**NOTICE OF REGULAR MEETING  
KERSEY PLANNING AND ZONING COMMISSION  
KERSEY MUNICIPAL BUILDING  
446 1<sup>st</sup> Street, Kersey, CO  
TUESDAY, FEBRUARY 6, 2024  
6:00 P.M.**

**Subject:** Puryear Change of Zone Request for D - Industrial Zoning

**Subject:** Highway 34 Transportation Center Lot 4 Site Plan Application

# ZONING AMENDMENT

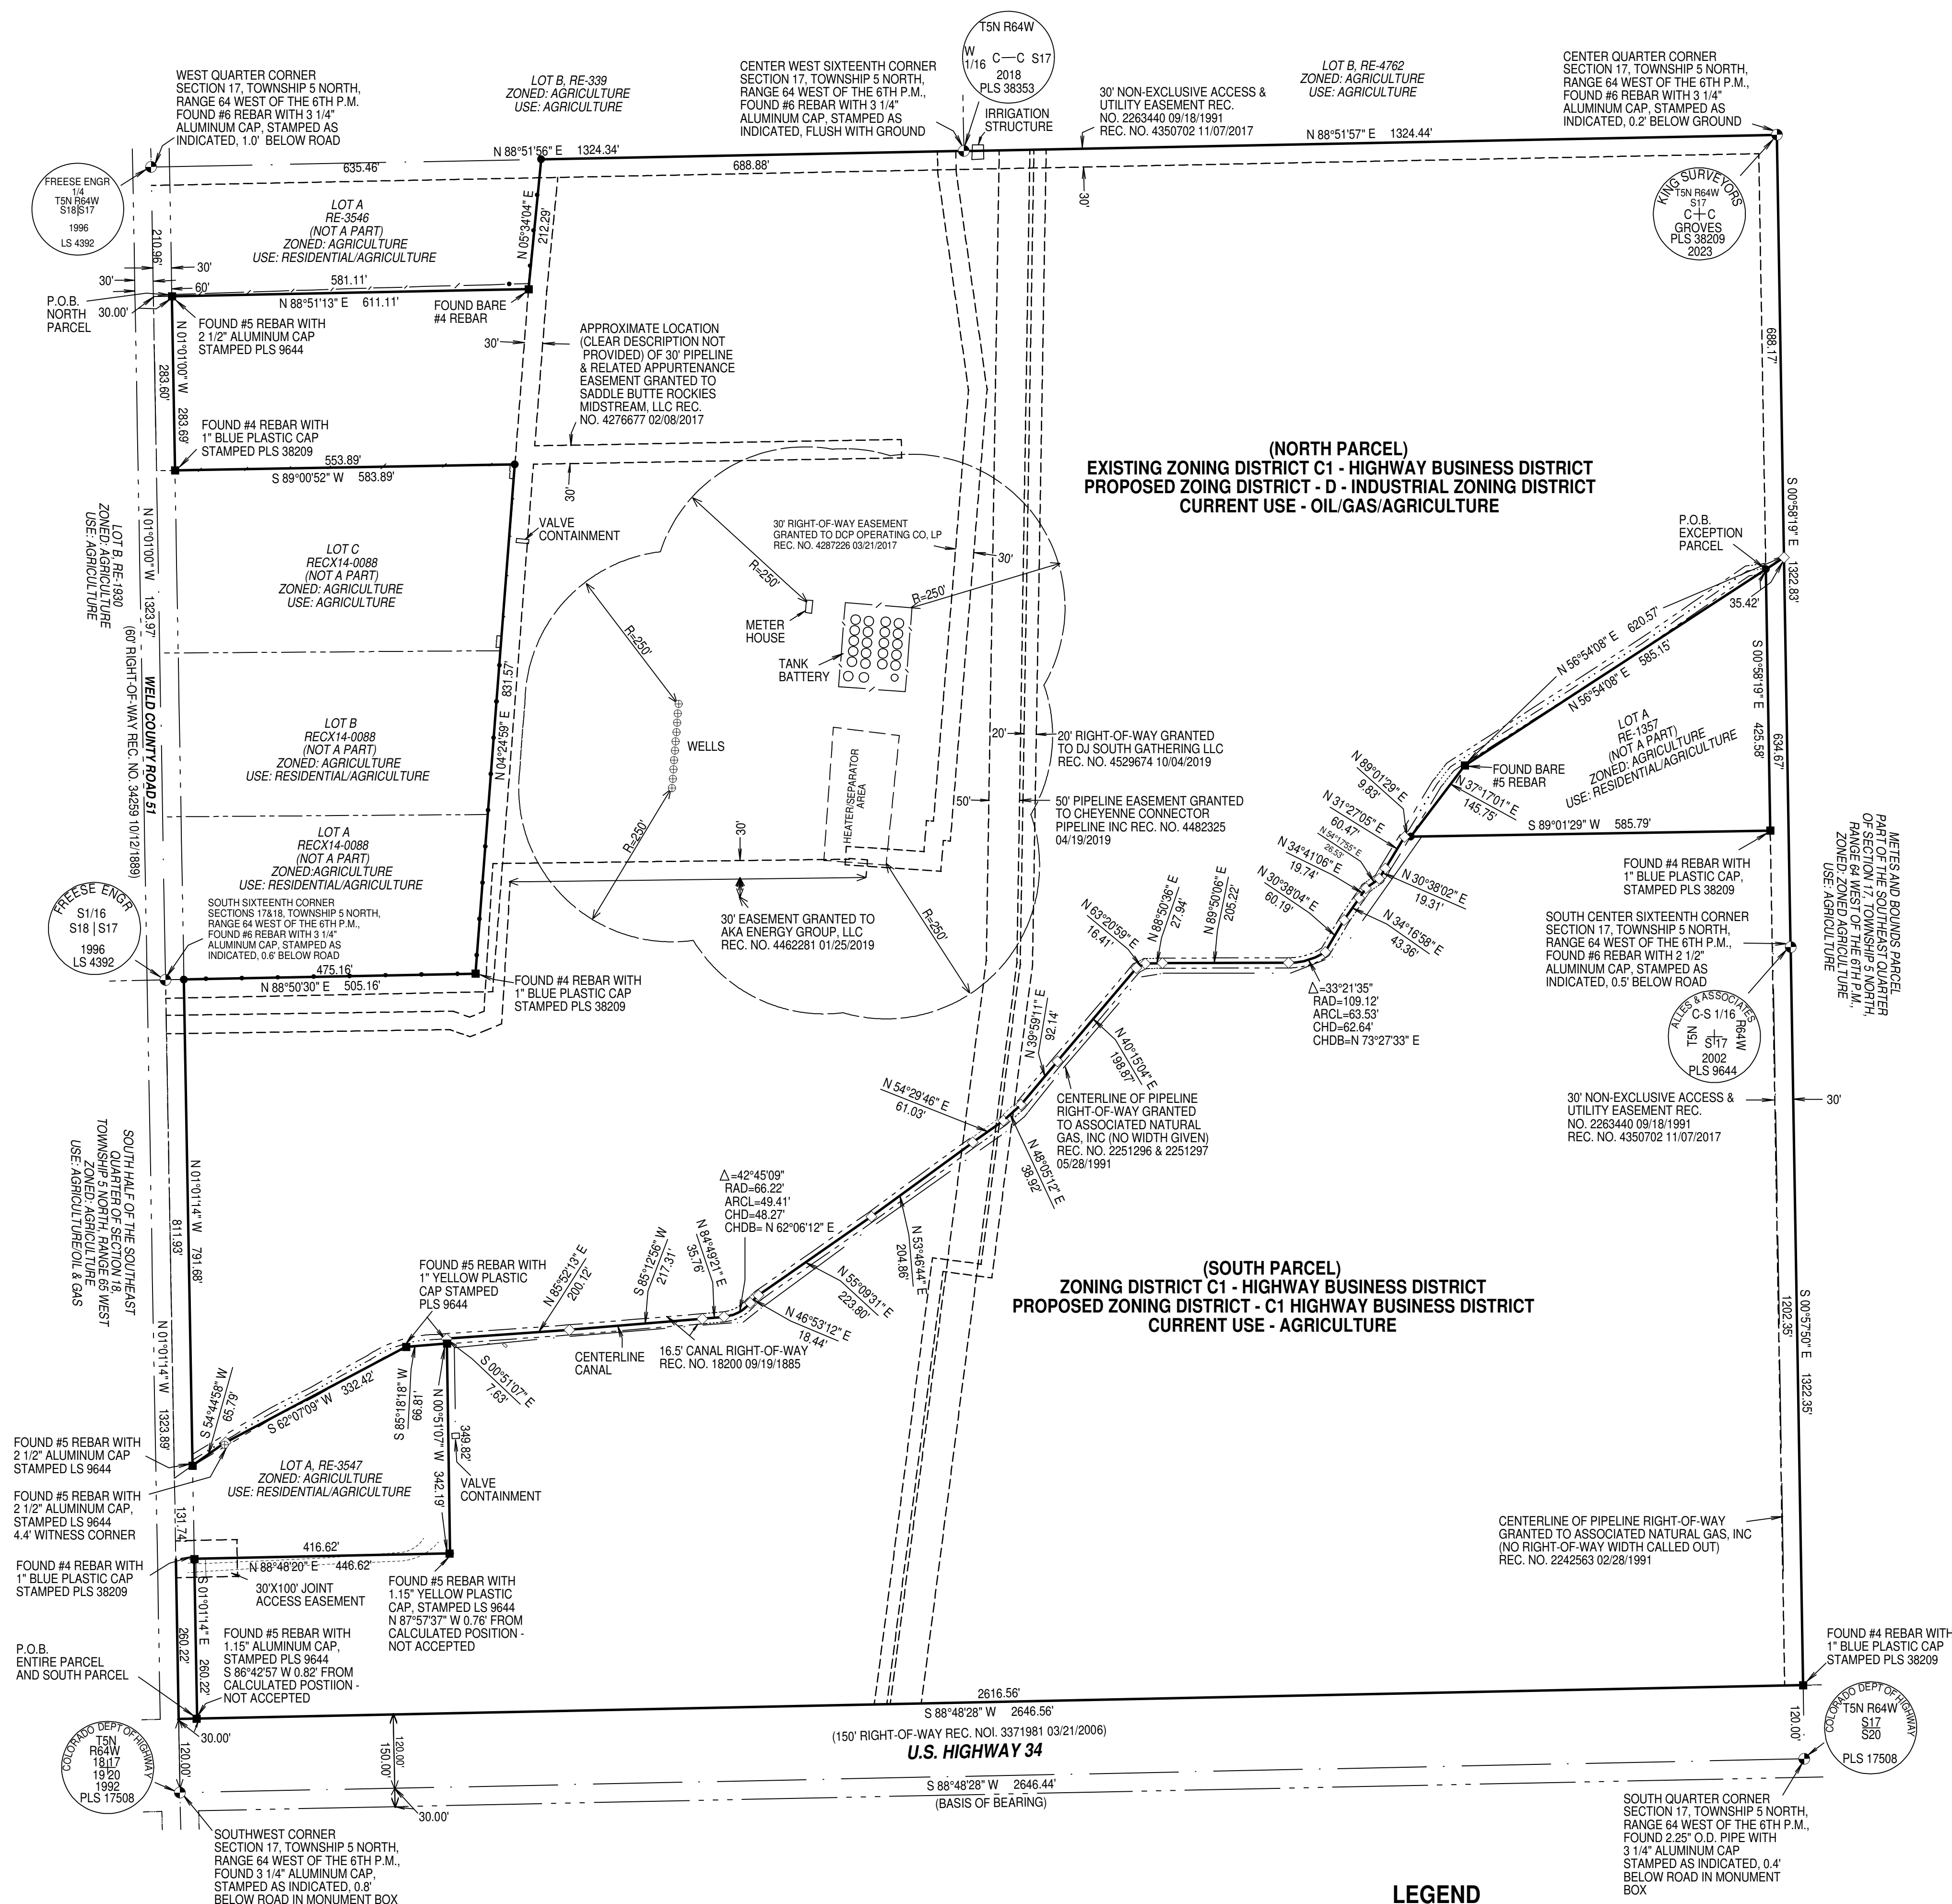
1. The owners of the Iron Lateral Ditch own an exclusive easement across this property that is not correctly shown on the plat of the property submitted to the Town (“Subdivision”). The easement width is the width of the ditch plus 25 feet from the toe or top of the bank of the ditch on each side of the ditch that lies on the Subdivision. The survey plat of the Subdivision should be amended to correctly show the location and width of the ditch easement.

2. The owners of the Ditch also own a historic access easement across the property from Weld County Road 51. The plat of the Subdivision should be amended to correctly show the location and width of the existing ditch access easement.

4. The owners of the Iron Lateral Ditch identify to the applicant and the Town that there may be subsurface waters that arise in this property, and that there are periods of time when, due to water flowing within the ditch system and otherwise, that portions of the property receive significant amounts of subsurface water that is very near to the surface or resides on the surface. The utility of certain portions of the property for construction of structures could potentially be unavailable. The ditch owners do not have any plans to alter its operations that would cure this surface and subsurface water status. A note should be inserted on the survey plat of the property regarding these issues.

5. The applicant should acknowledge that historic irrigation and drainage patterns should be maintained on the property so that there are no changes in the operation of the ditch facilities. A drainage plan should be prepared by a licensed engineer to analyze and report on any change in drainage patterns caused by any change in use of the property. The ditch owners should be provided

with a copy of that plan and the ditch owners should have the opportunity to review and comment on the plan. The applicant should be required to maintain the existing irrigation and drainage patterns so that the quality of water entering the ditch from irrigation and from precipitation and other sources is maintained, and so that there is no change in point or type of drainage into the ditch that will occur. The applicant should be required to monitor and identify any pollutants or other hazardous materials that enter the ditch and should agree to stop any such deposit in the ditch system. A note should be inserted on the survey plat of the property regarding these issues.

6. The following notes shall be inserted by the Applicant onto the permanent Subdivision covenants or Subdivision plat or both the covenants and the plat:

Sheet PV1

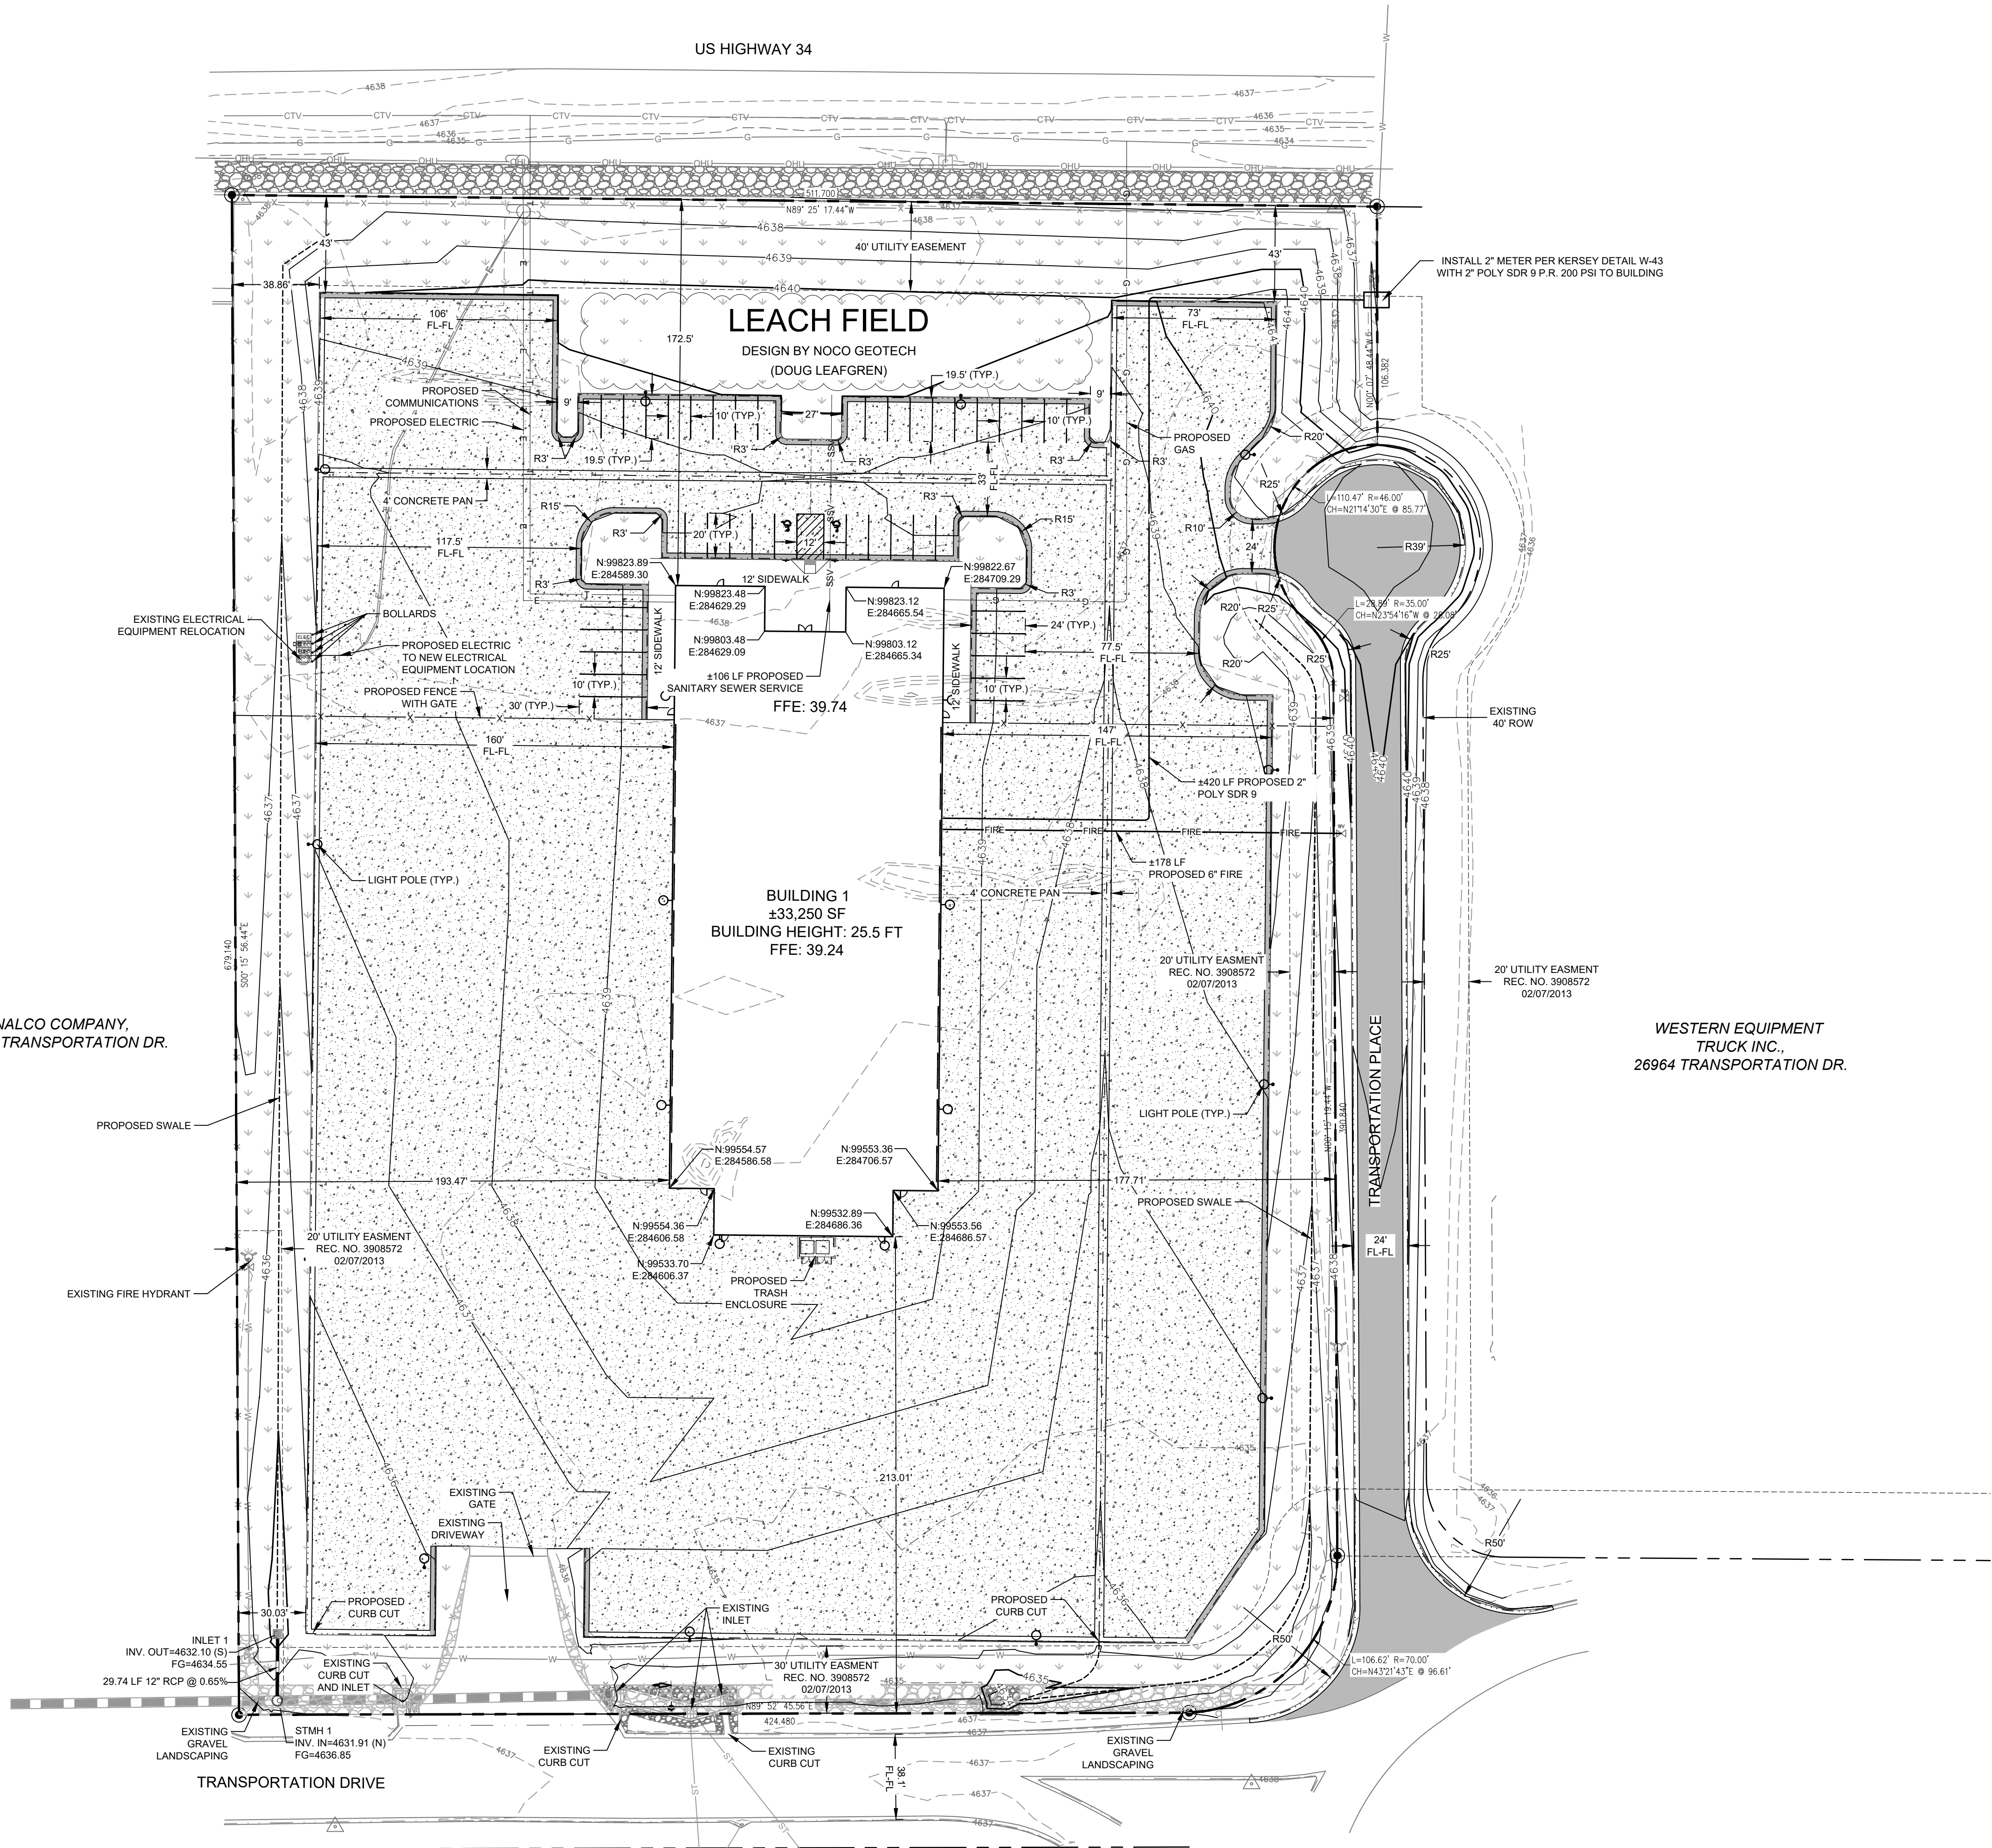
1. Weld County Department of Public Health and Environment (WCCDPHE) requests that the applicant clarify on the plans that the property will use a septic system until sewer is available and they will obtain all necessary permits from WCCDPHE and the Colorado Department of Public Health and Environment.

**Staff Comment:** The Town Engineer is still reviewing the grading and drainage plans. The applicant must address his comments prior to recording of the site plan maps.
